January 30, 2023

Re: 5th Submission Review – Lona / Forum Vista Creek – Master Plan, Site Plan and Final Plat
Application Number: **DA-2248-01**
Case Numbers: **2021-7009-00; 2021-4025-00; 2021-3051-00**

Vista Creek Multi- Aurora, Colorado

FIGURE 13

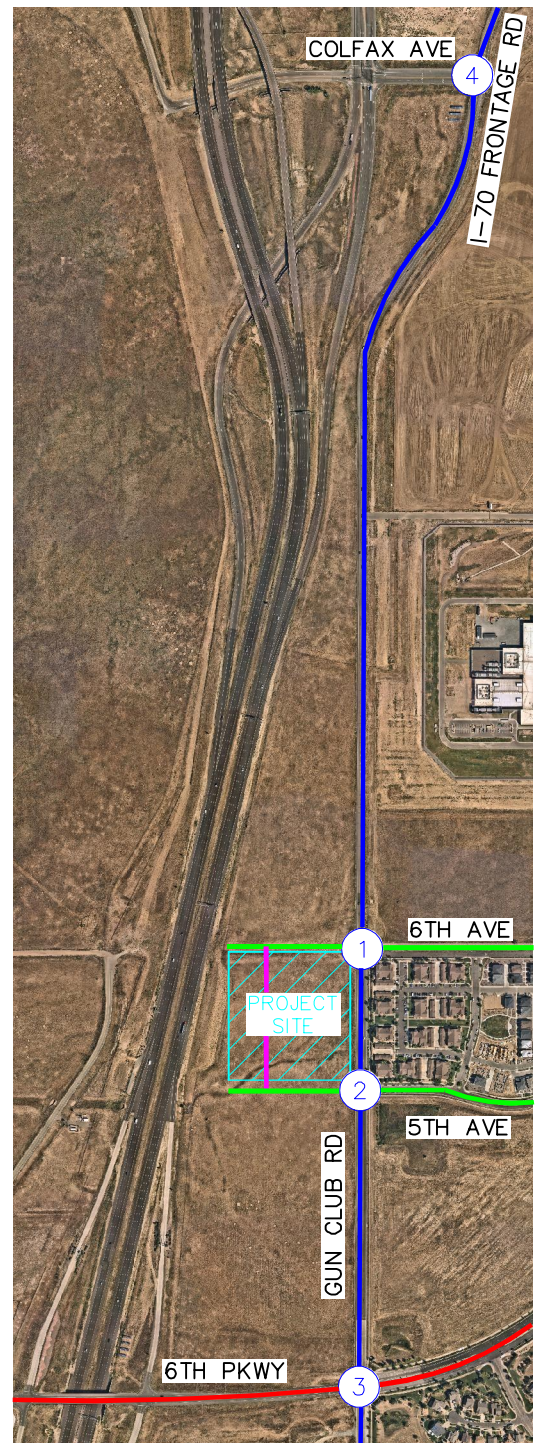
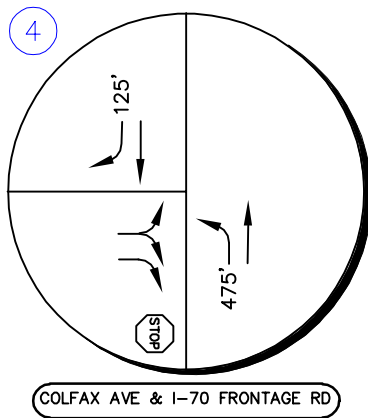
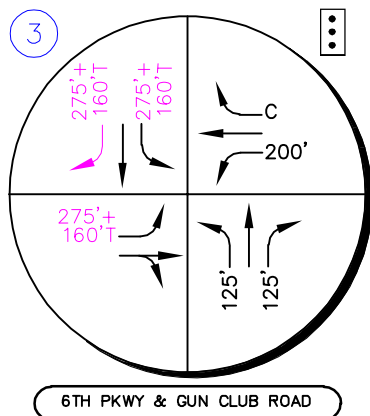
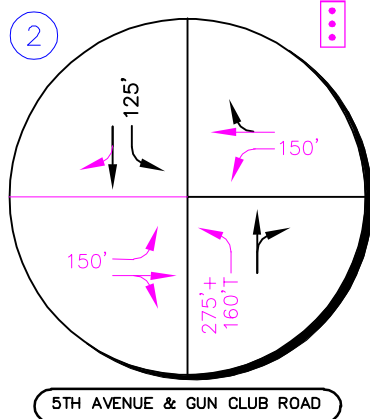
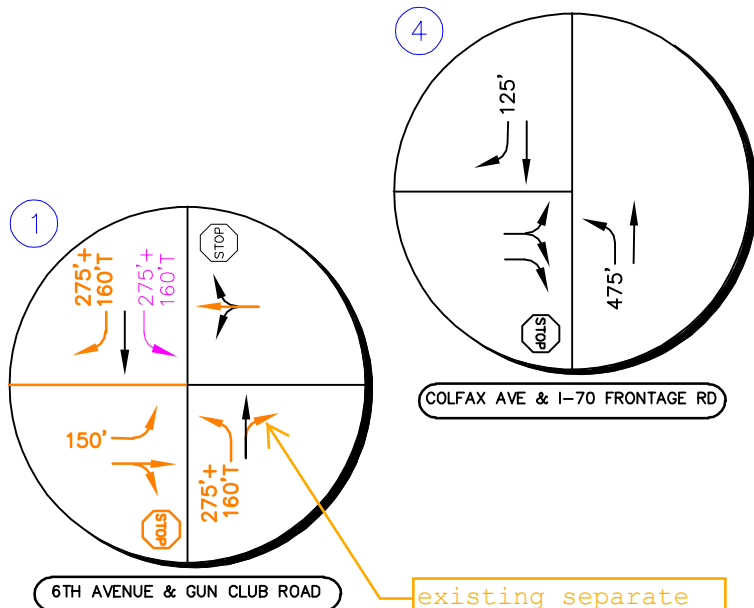
2.need to maintain existing separate NB right turn lane, update analyses

keep existing
separate NB right
turn lane, update
analyses

Note that storage lengths may
be reduced to meet calculated
queue lengths with a minimum
storage length of 50'.

The revised study was updated with a northbound right turn lane at the intersection of 6th Avenue and Gun Club Road.
